# Service Bulletin

S.B. No: 187

**Title:** INSPECTION FOR CLEARANCE BETWEEN RUDDER PEDAL AND MIXTURE/PROP. SPEED BRACKET AND FOR GROUND TOWING DAMAGE. ALSO INCLUDES GENERAL RUDDER PEDAL CLEARANCES.

**Applicability:** T67M200 (Works No. 2264 & 2265 only), T67M260 and T67M260-T3A.

FIGURE 9

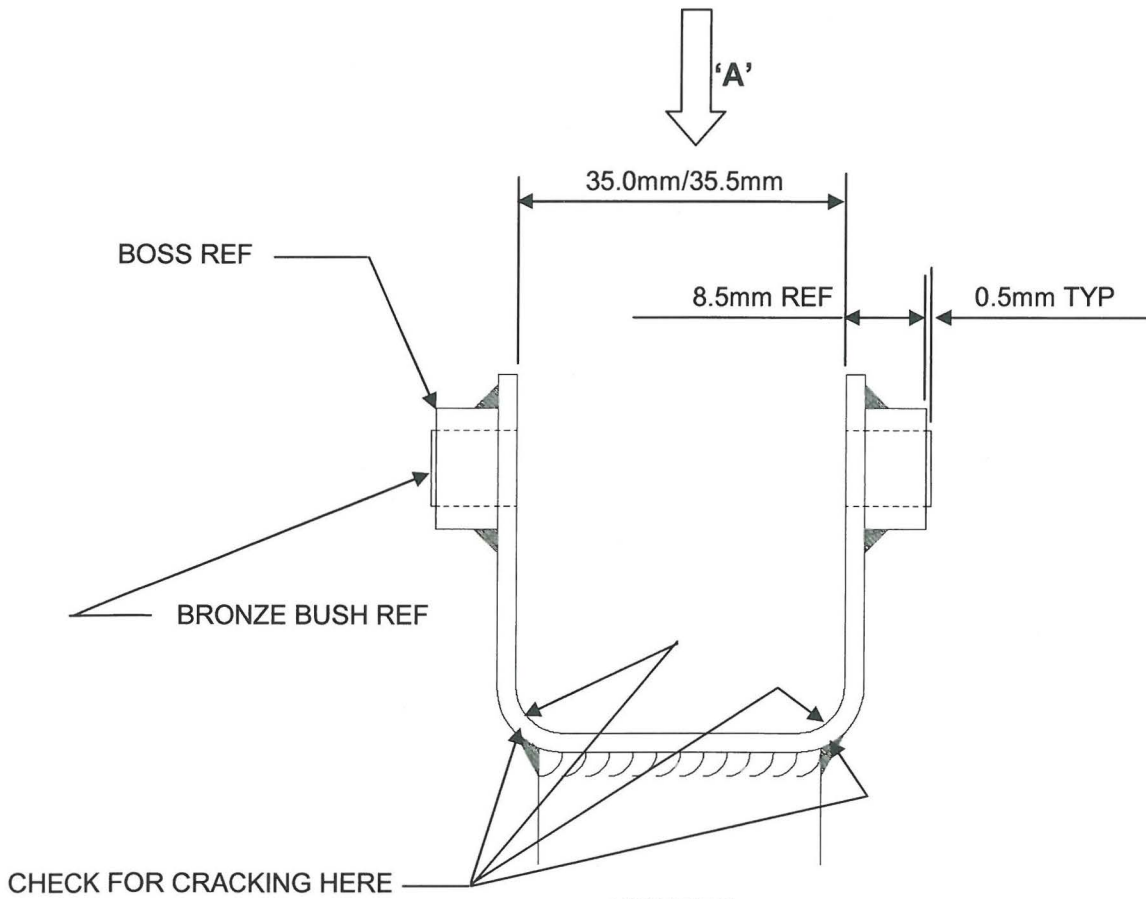
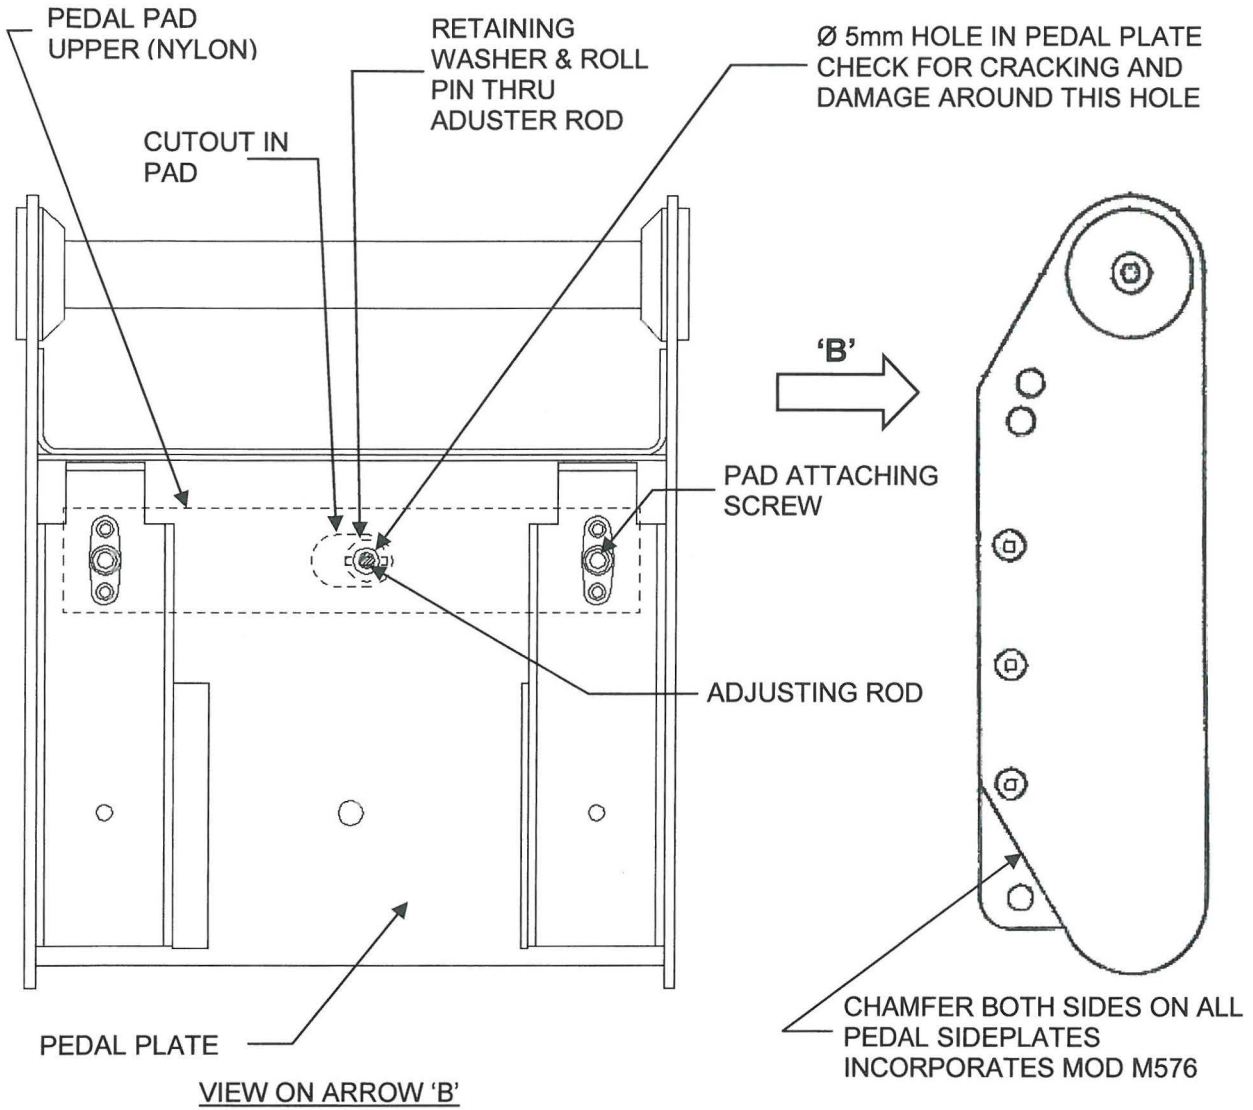
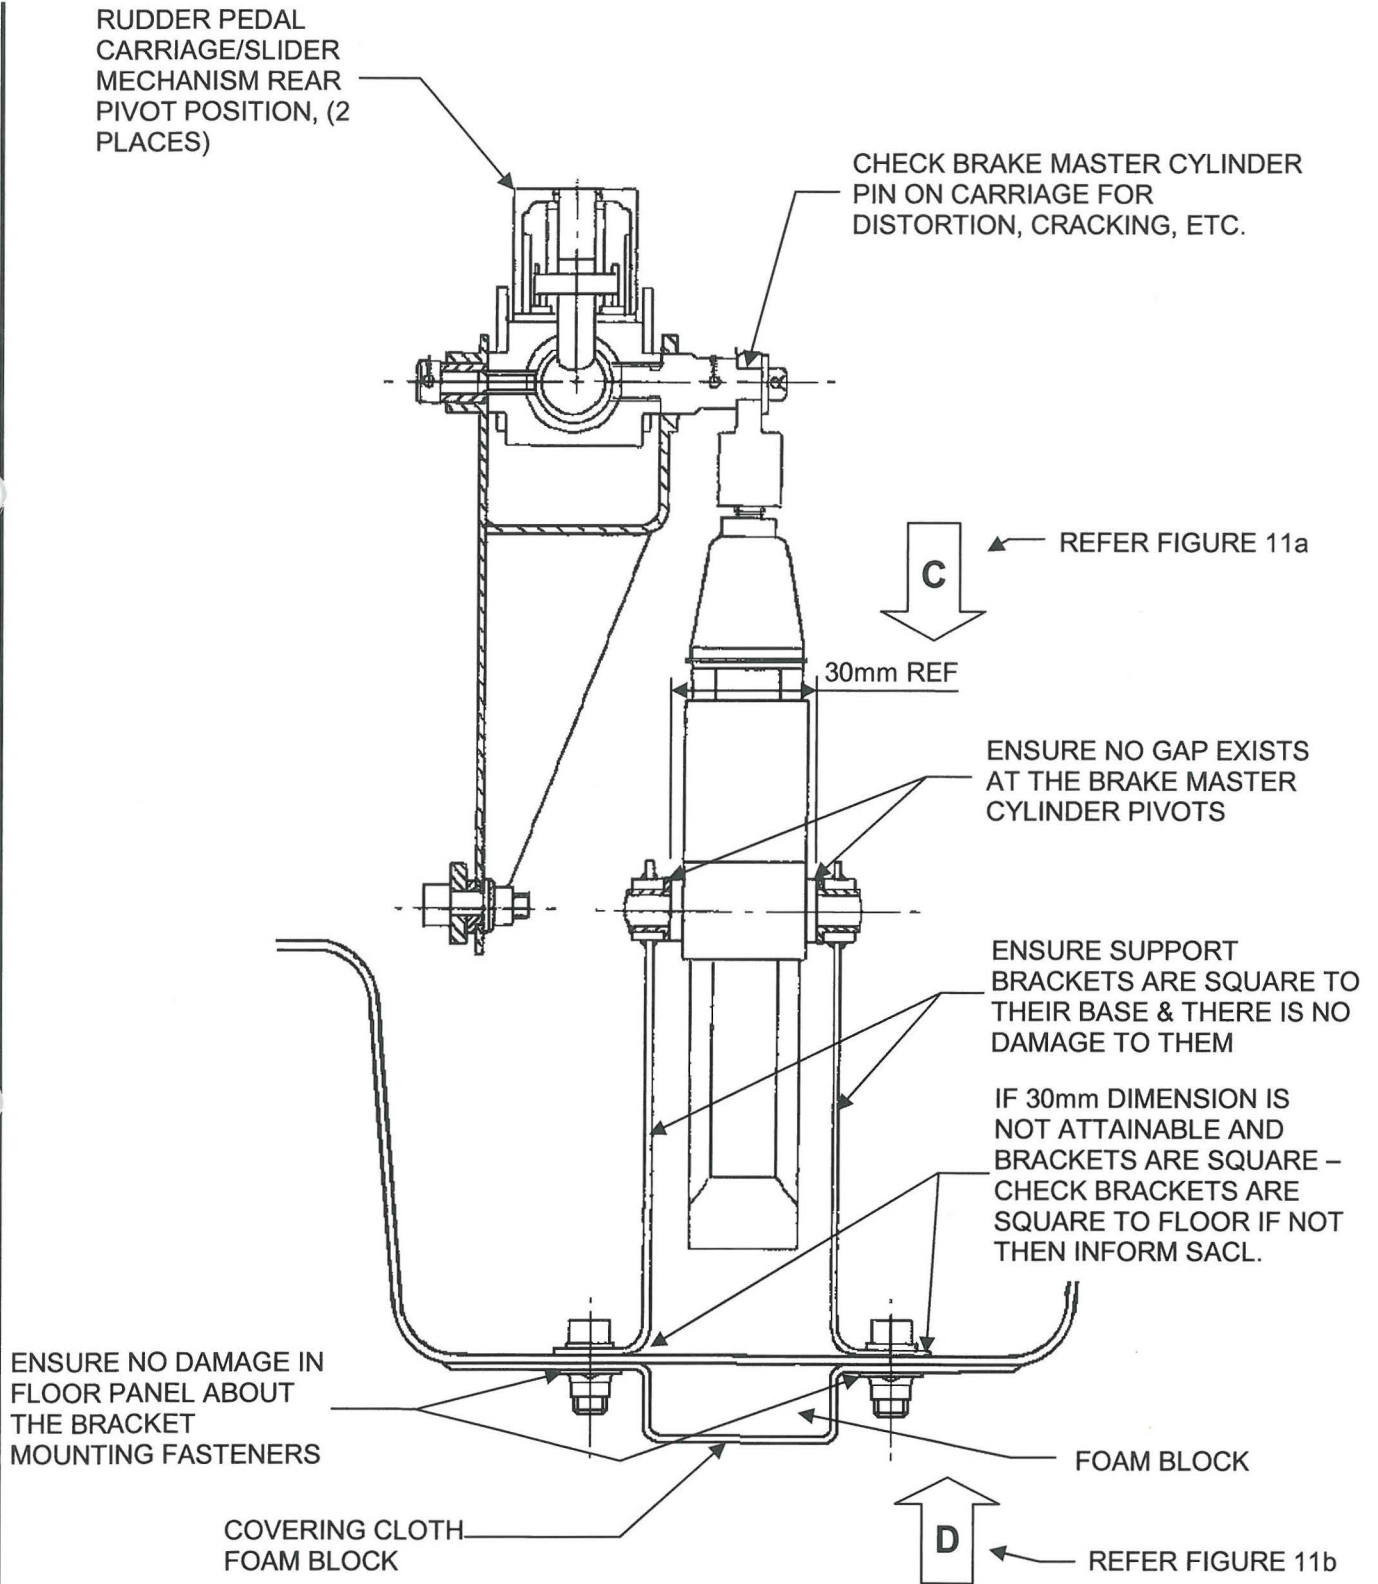
15. Check that the 'U' brackets are parallel and square to the rudder bar axis, Figure 9 View on 'A' refers, this alignment is important at rudder position 3 with reference to attaining the required clearance between pedal and mixture bracket, ref paragraphs 1 and 2. Also ensure that the rudder pedal carriages have full and free movement. If binding is suspected then check the 'U' bracket internal dimension. This should measure 35.0mm to 35.5mm, also check that the pivot bush protrudes from its boss by 0.5mm. If the bracket internal dimension is greater or less, or if out of alignment then the bracket should be checked for cracking, refer Figure 9. If cracking is found then return rudder bar to SACL for rework. Finally check length of carriage pivot bolts, reference Figure 4, if binding is noted then replace bolts with bolt part number T67B-08-537 this introduces a bolt 15 mm long, measured from under head, and invokes Mod M808 "Introduction of Shortened Pivot Bolt to Rudder Pedal Slider Assembly Mounting". Also refer to SB130 "Inspection of Rudder Pedals for Adjustment Restriction".

**FIGURE 10**

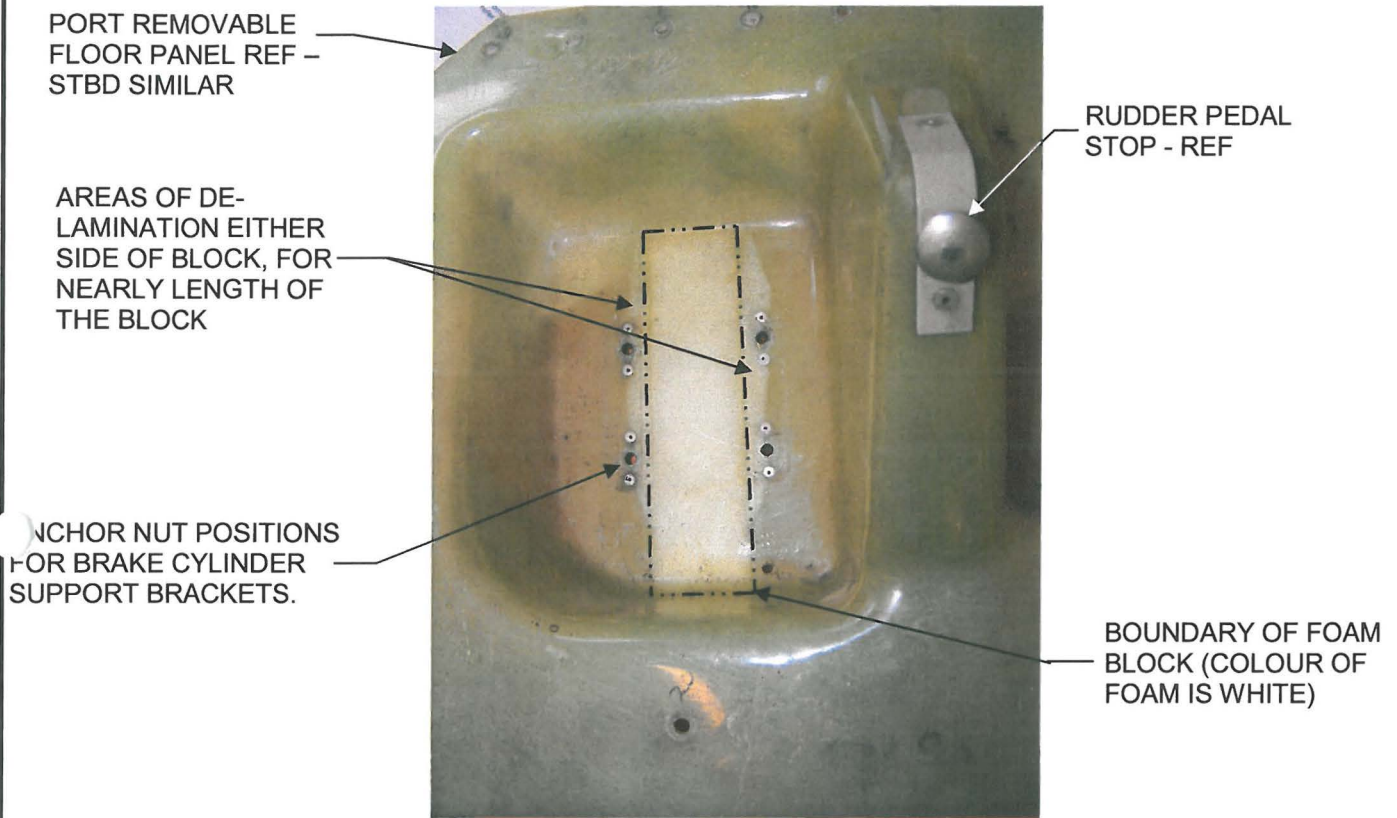
28. Ensure Mandatory Mod M576 has been invoked; CAA AD 013-05-94 refers. Pedal side plate should be as Figure 10.
29. Check structural integrity of pedal pad assembly especially around adjuster pushrod hole pedal plate, Figure 10 View on Arrow 'B' refers, if plate is cracked or damaged the pedal pad is to be repaired. Ensure riveting is secure, if rivets are loose then they have to be rectified. Contact SACL for new pedal pad assembly, materials and any applicable repair scheme.

**FIGURE 11b**  
**PHOTOGRAPH ON ARROW D**  
**VIEW ON UNDERSIDE OF REMOVABLE PANEL SHOWING EXTENT OF DE-LAMINATION**

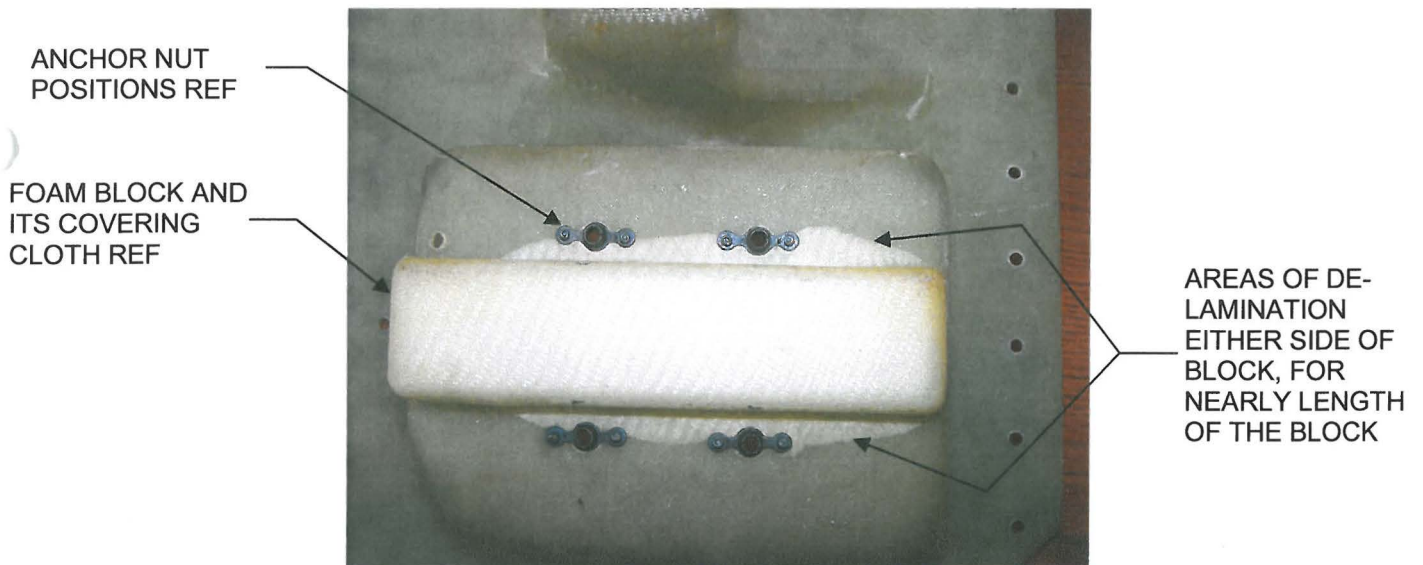
Further to issue 2 an incident has been reported of the brake master cylinder becoming detached from its support brackets causing de-lamination to the port GRP floor panel. This failure occurred during aircraft taxiing. The failure was the direct result of the aircraft towing angle being exceeded.

10. Ensure that there is no gap at the brake master cylinder pivot points and that the support brackets are securely mounted to the floor panel, i.e. not loose, they should not deflect if base fastenings are sound. If bracket is seen to be suspect, i.e. out of square, twisted or bent, remove brackets and replace with new brackets if damaged. Check that there is no damage to the bracket anchorages in the removable floor panel, damage will show as whitening in the laminate surrounding the anchor nuts and foam reinforcement block, if in doubt remove panel and check anchor nuts for security. Figure 11 refers. If the floor panel is found to be damaged it is to be repaired or new panel fitted, refer to SACL Customer Support Department. If damage found then proceed as indicated by paragraphs 11 and 12. When rectified ensure all clearances and checks are accomplished as related to in this Service Bulletin.

FIGURE 12

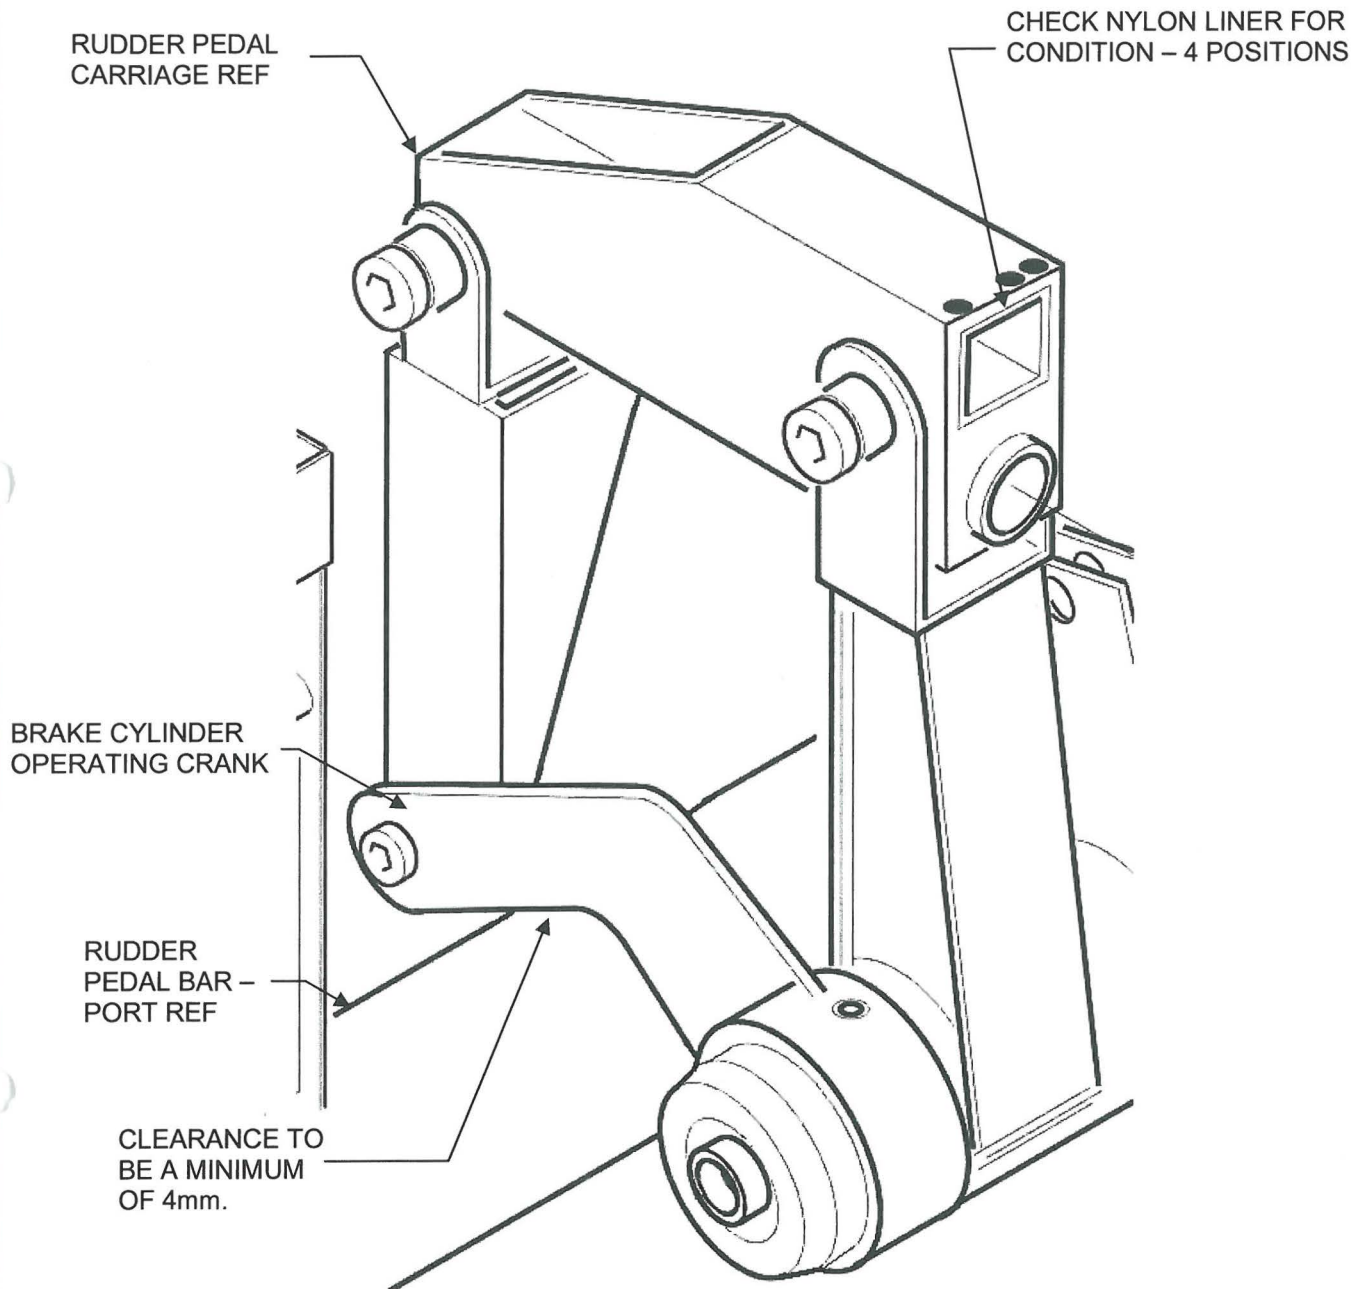
26. Ensure the nylon liners in the rudder pedal carriages are in good condition and not worn, Figure 12 refers, replace liners if unsatisfactory. Return carriages to SACL for replacement of liner.

30. Ensure that the brake operating crank, as shown at Figure 12, has a minimum clearance of 4mm relative to the rudder pedal bar following all checks and rectifications. Allow for various brake conditions, refer paragraph 31.2. Should bar show signs of chaffing check depth of groove. If depth is 0.0mm to 0.5mm, remove rudder bar, blend out groove, repaint and refit. If the groove is to a depth greater than 0.5mm, remove rudder bar and return to SACL for repair or replacement.
